FIRST DRAFT MINUTES

February 18, 2021 Standards Committee Meeting

RE: Minutes from the February 18, 2021 Standards Committee Meeting

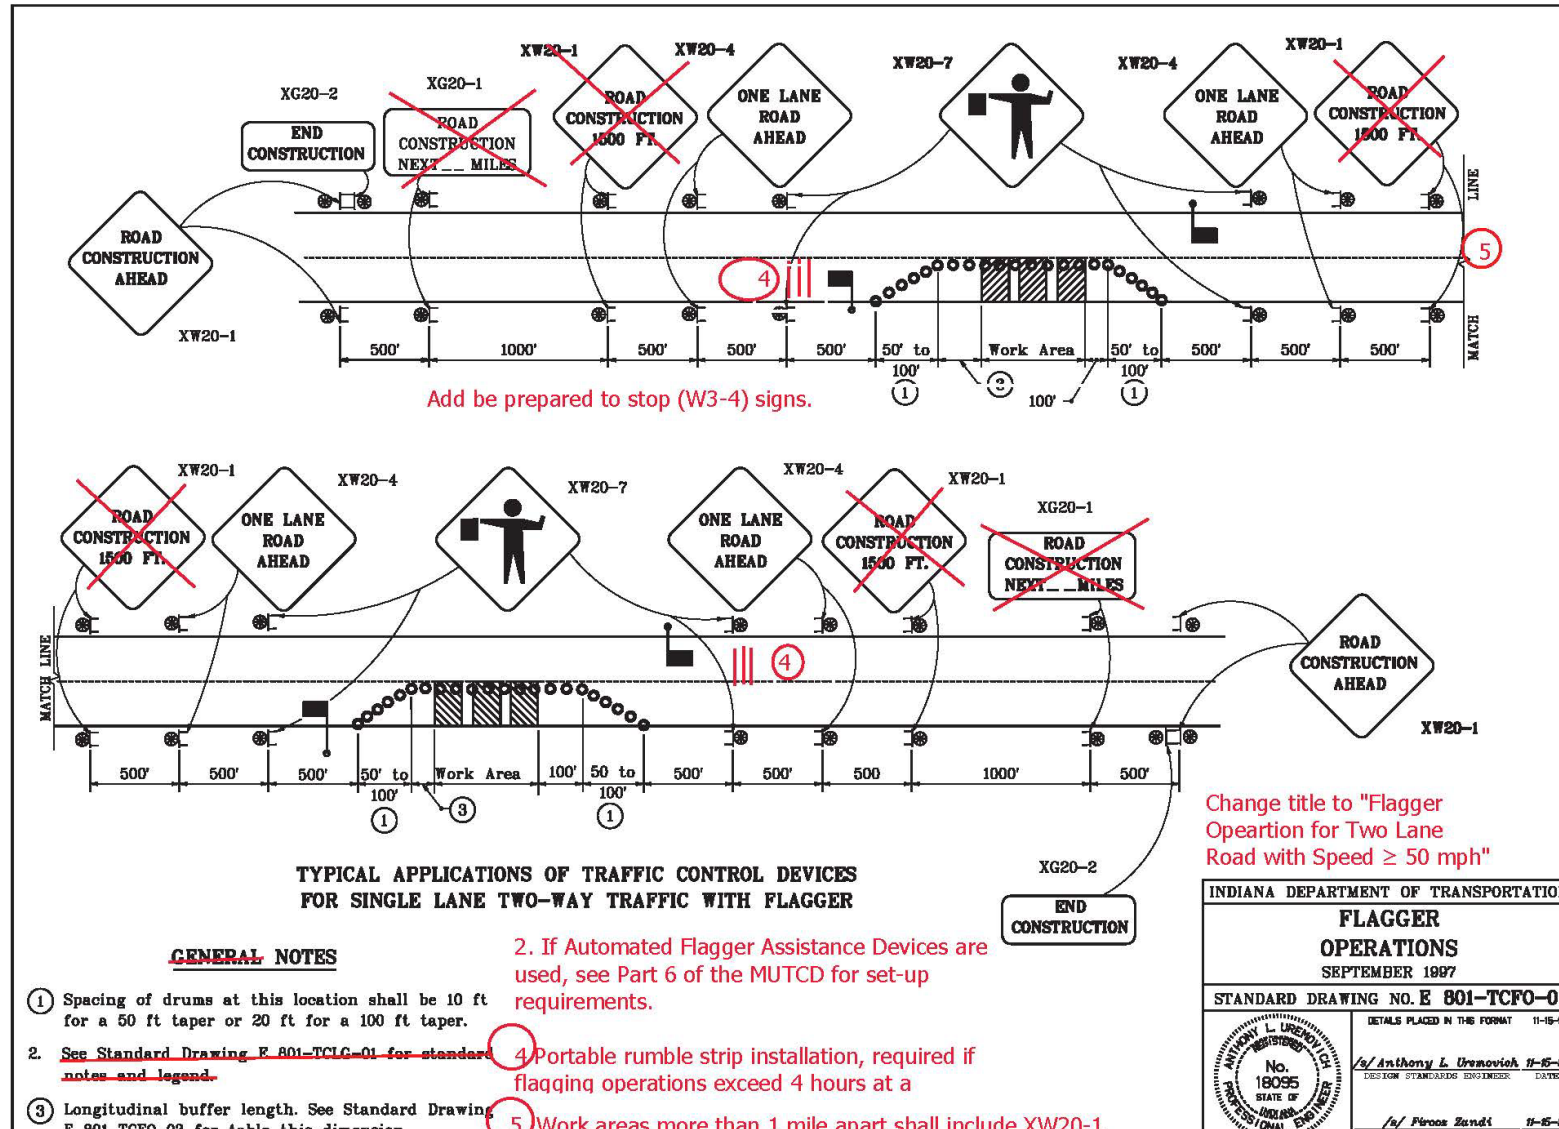
Add index sheet and simplified sheet for flagger operation on two lane road with speed < 50 mph.

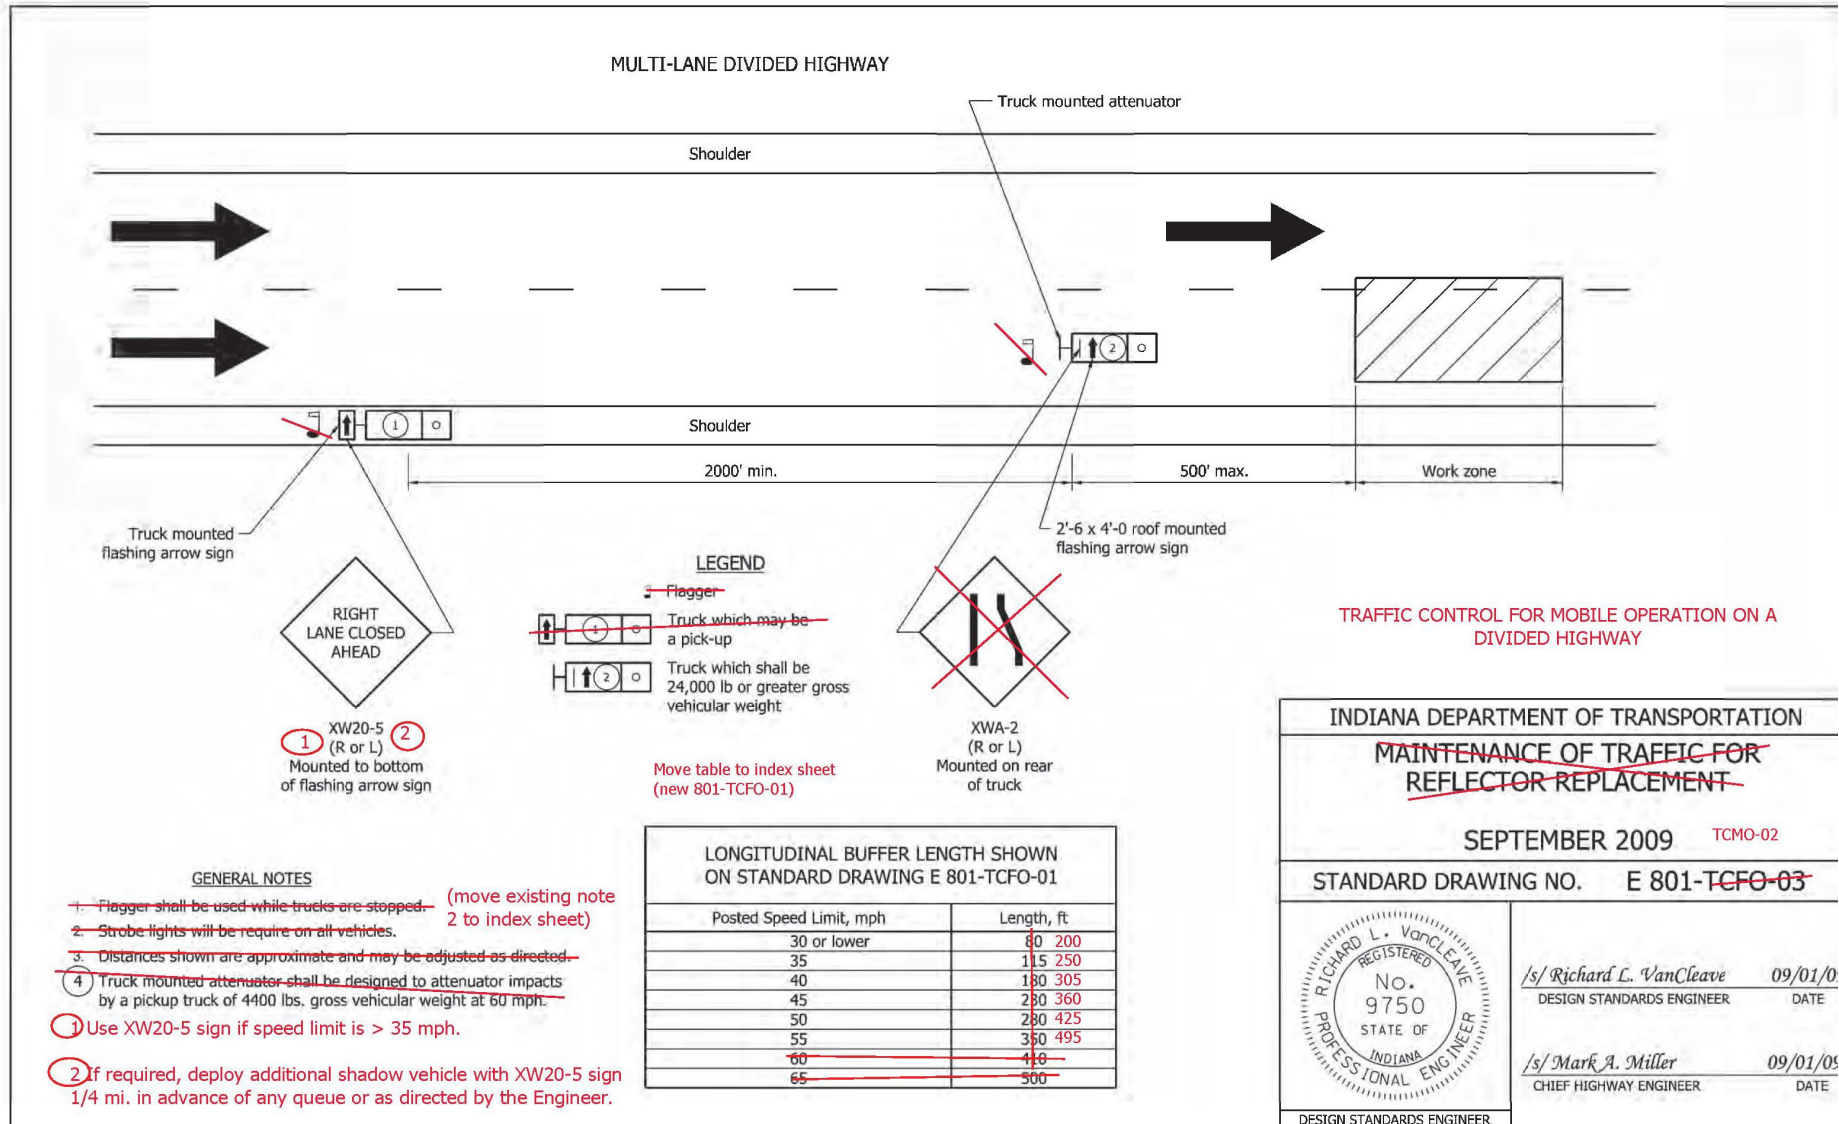
Create New Sheet for Flagging Operations < 50 mph similar to IMUTCD Figure 6H-10

E 801-TCFO-05 TRAFFIC CONTROL FOR OVERHEAD INSTALLATION (WITH MARKUPS)

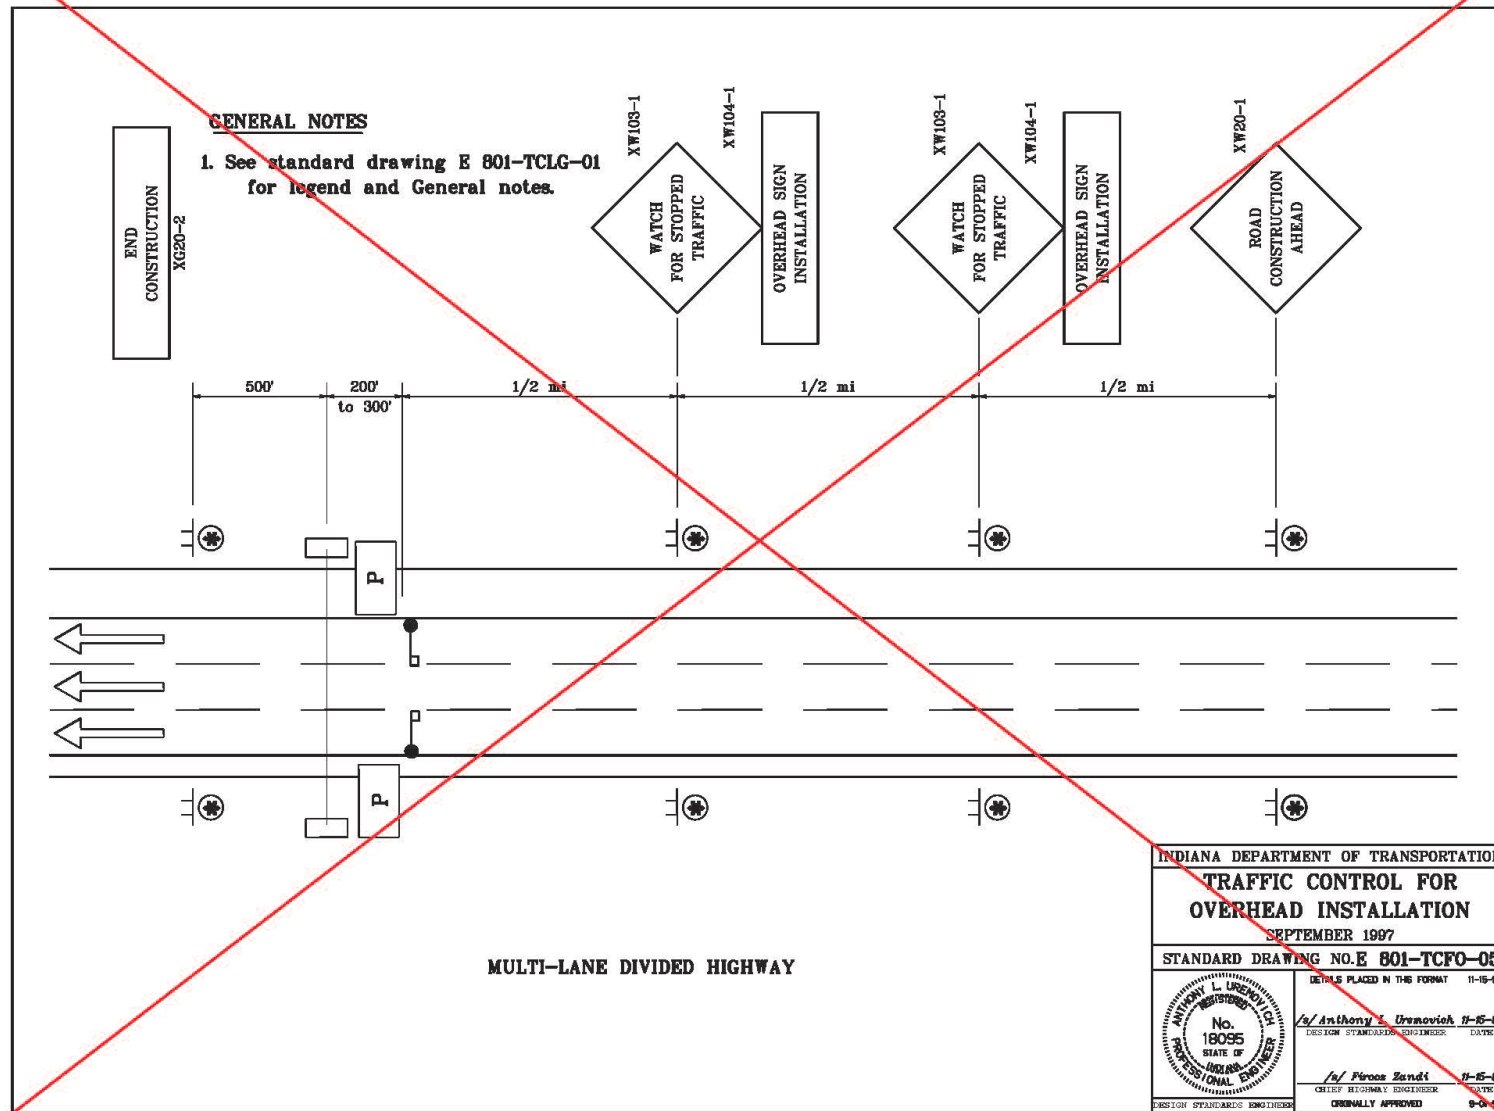
DELETE

E 801-TCFO-06 TRAFFIC CONTROL FOR INTERSECTION WORK (WITH MARKUPS)

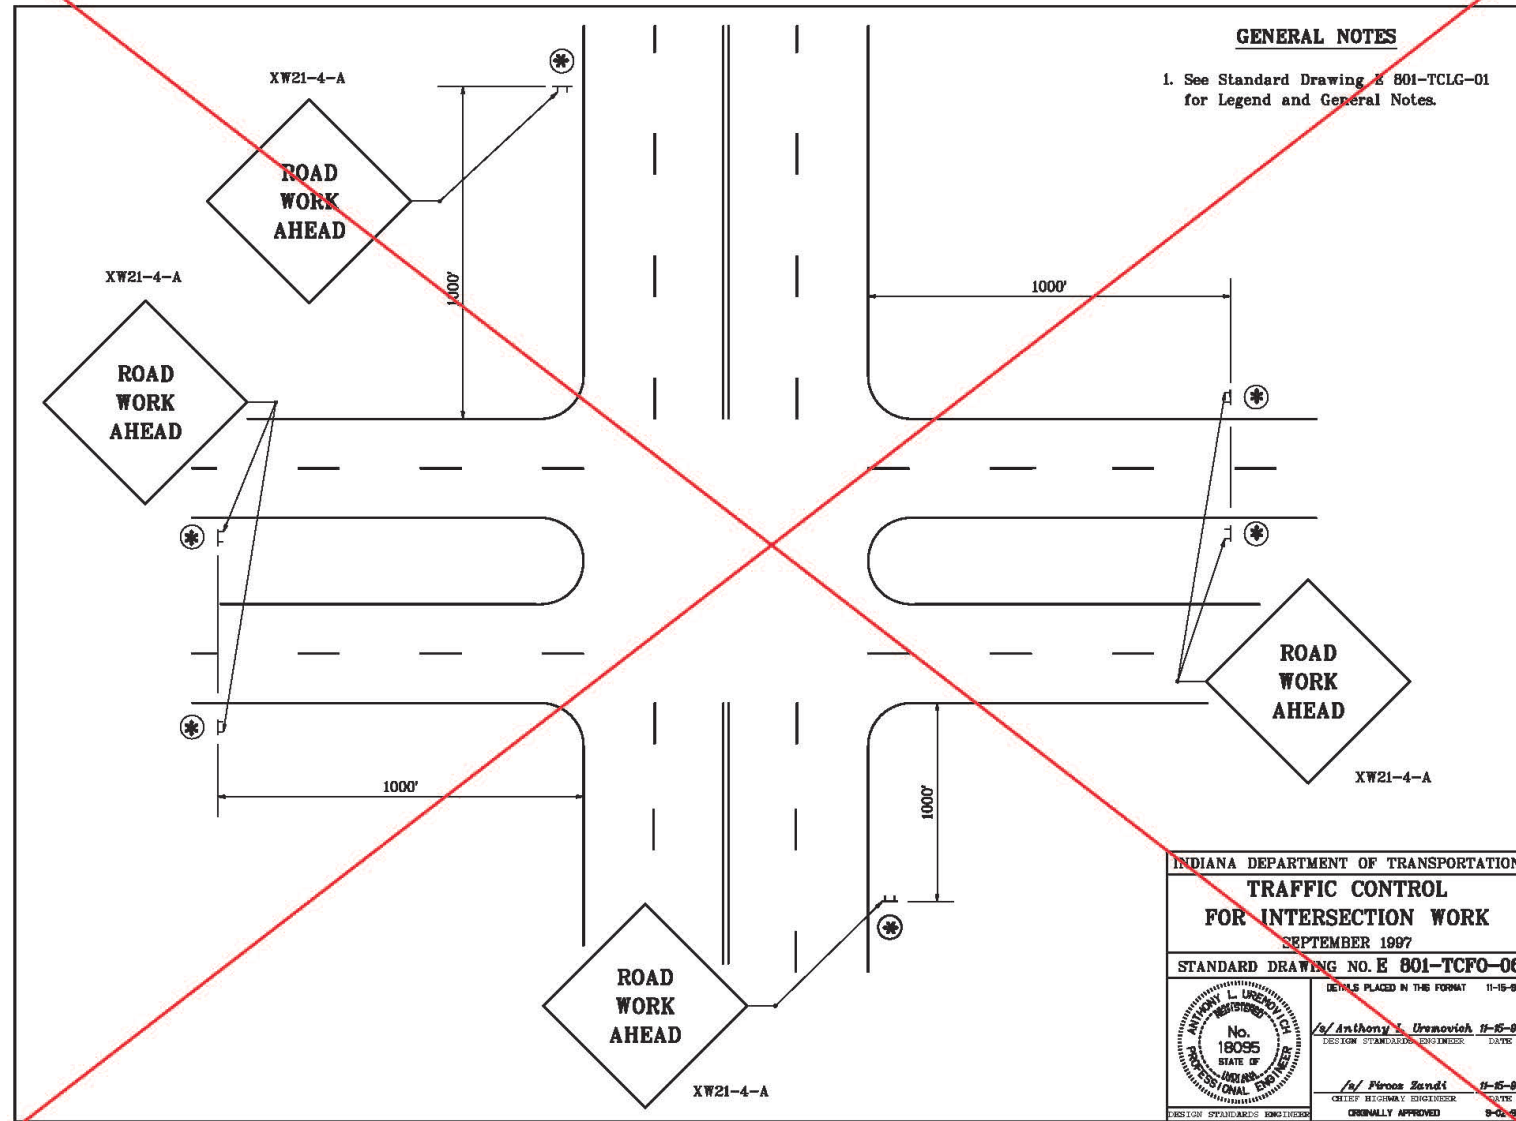
DELETE

E 801-TCTC-05 TRAFFIC CONTROL FOR DAYTIME LANE CLOSURE (WITH MARKUPS)

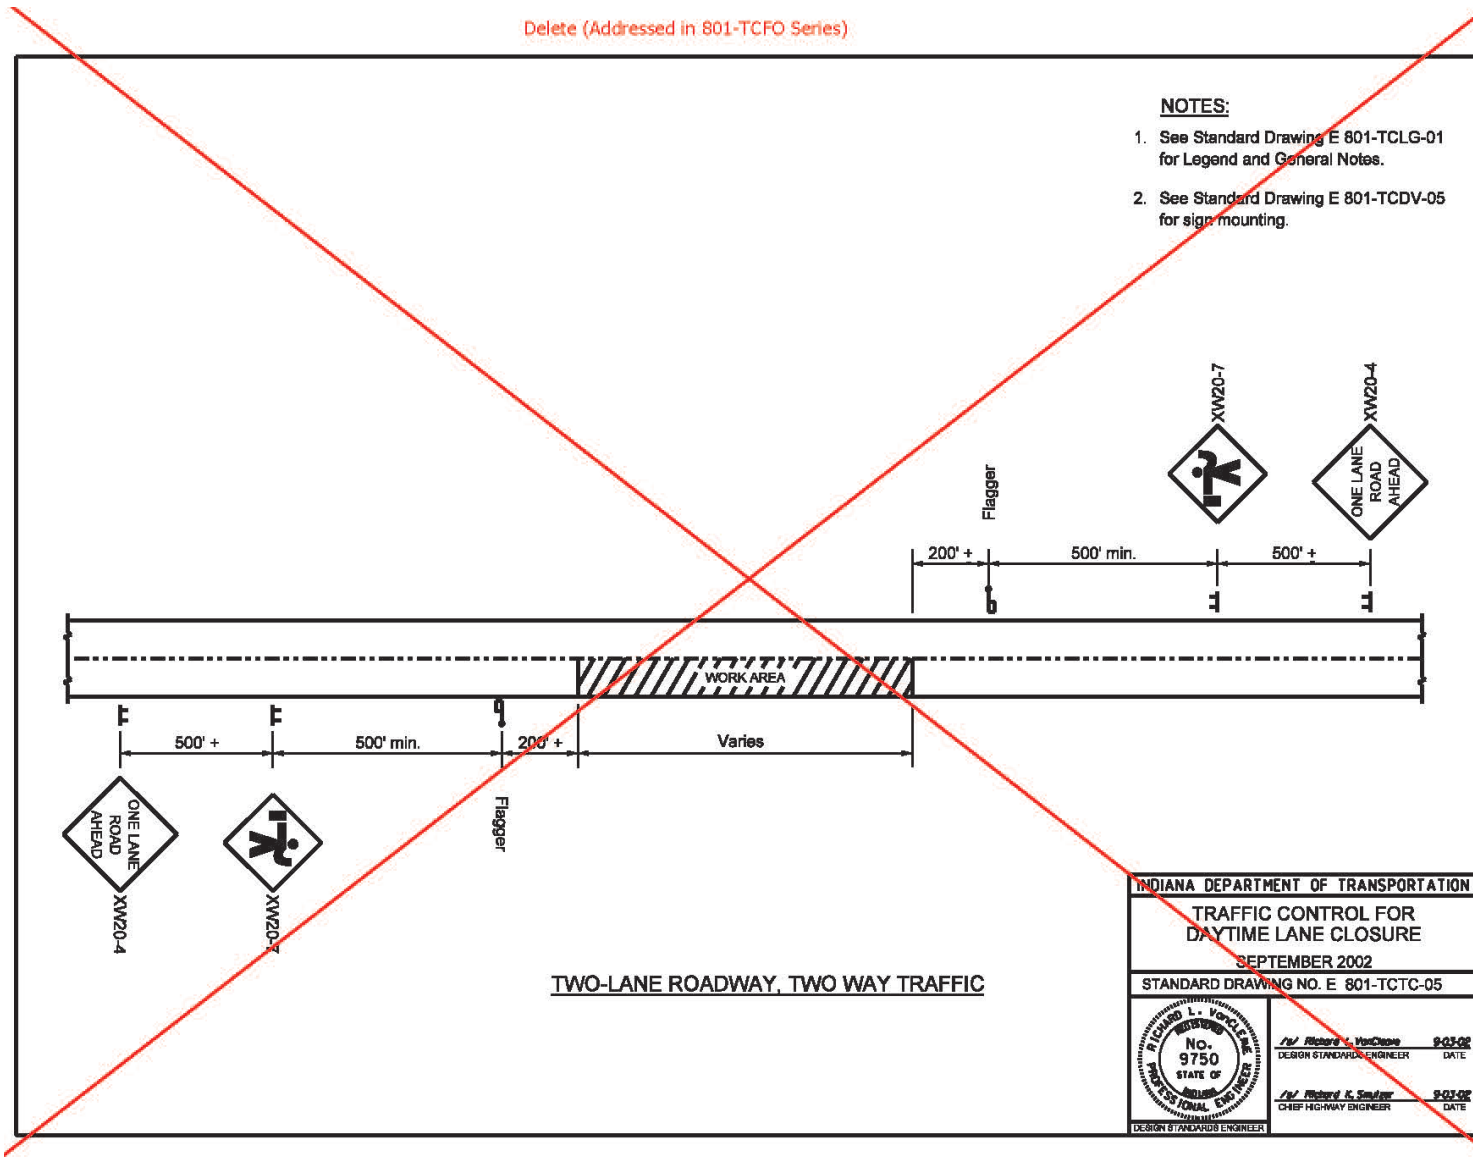
Delete (Addressed in 801-TCFO Series)

E 801-TCTC-06 MAINTENANCE OF TRAFFIC FOR RPM CASTING INSTALLATION (WITH MARKUPS)

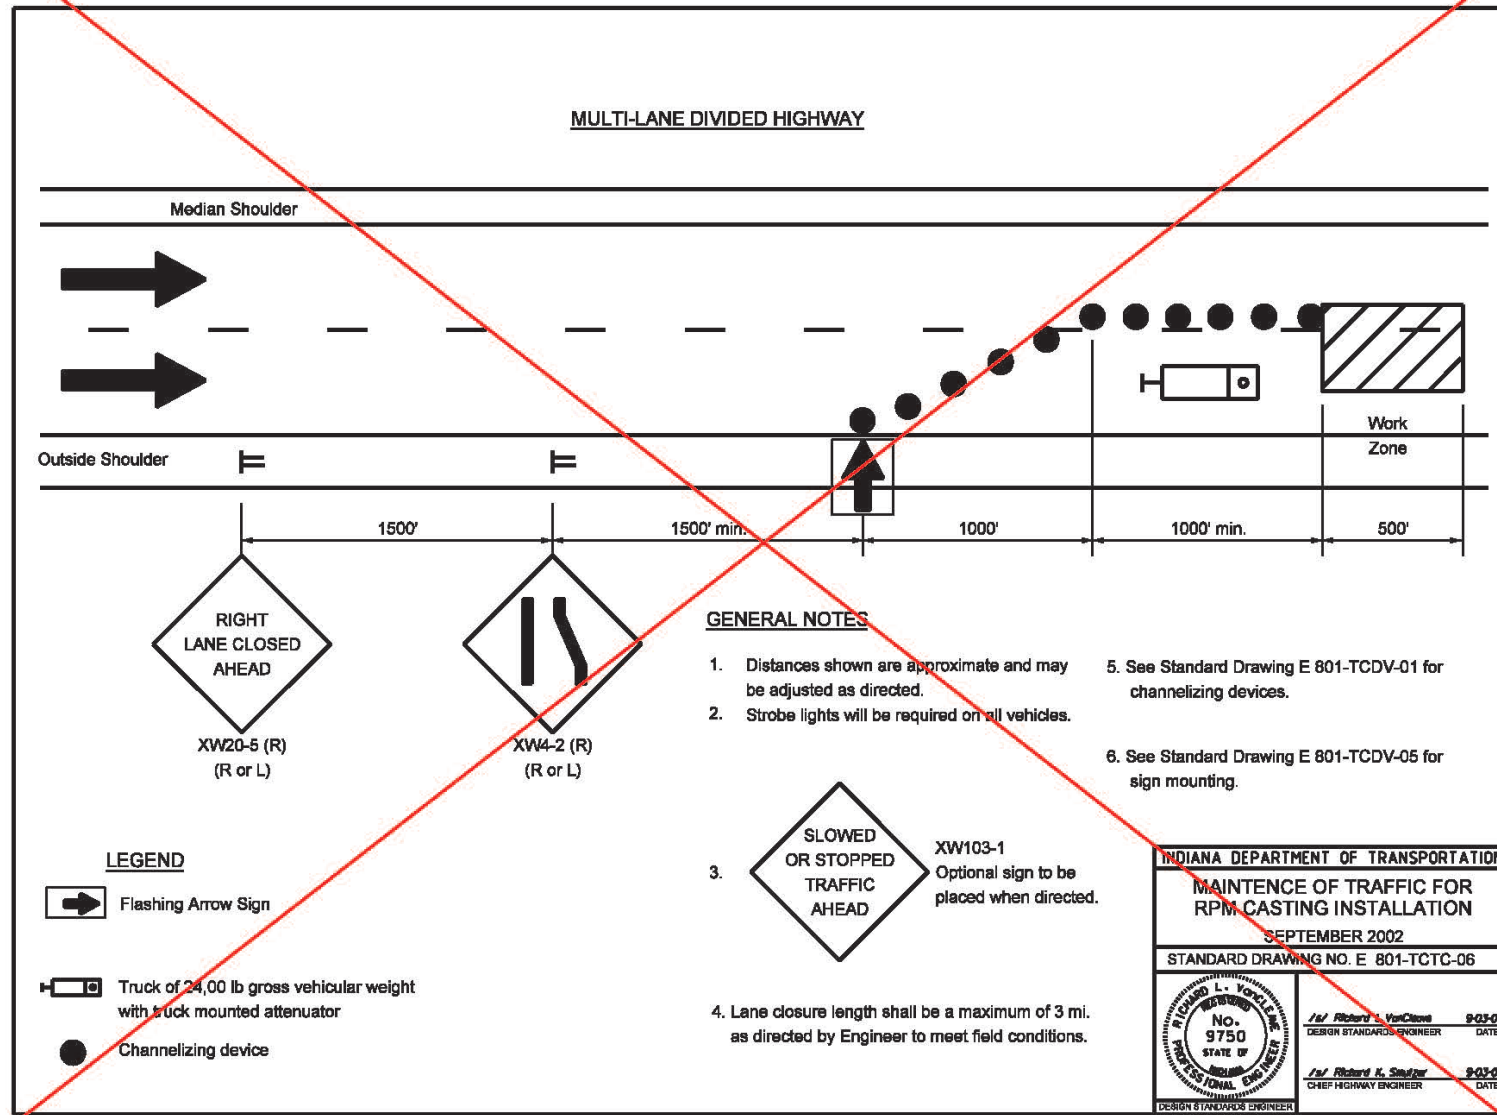
(Duplicate of Existing 801-TCFO-03 and Proposed 801-TCMO-02)
